Macan E-box Water Intrusion Causes Electrical Errors

Vehicles Affected

Models	Model Year	Model Type	VIN Range	Vehicle-Specific Equipment
Macan	As of 2019 up to 2022	95B	N/A	N/A

Figure 1

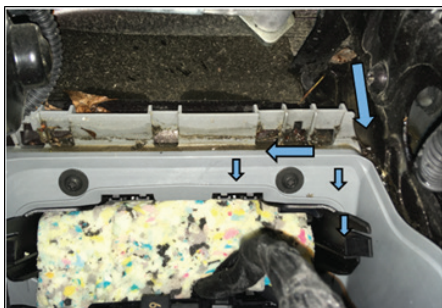
This condition may be the result of water entering the e-box and causing corrosion on the contacts or splices. When investigating, open the e-box and look for evidence of water intrusion.

Note the object area of the blue arrows (in figure 1) and note if there are traces of water related residue on the bottom of the e-box (like in figure 2).

Also, look for corrosion on the contacts or splices (Figure 3).

Remove existing corrosion from the splices and wiring and reattach to the e-box. Follow instructions in the attached document. Please note: it is necessary to replace the cover for the e-box.
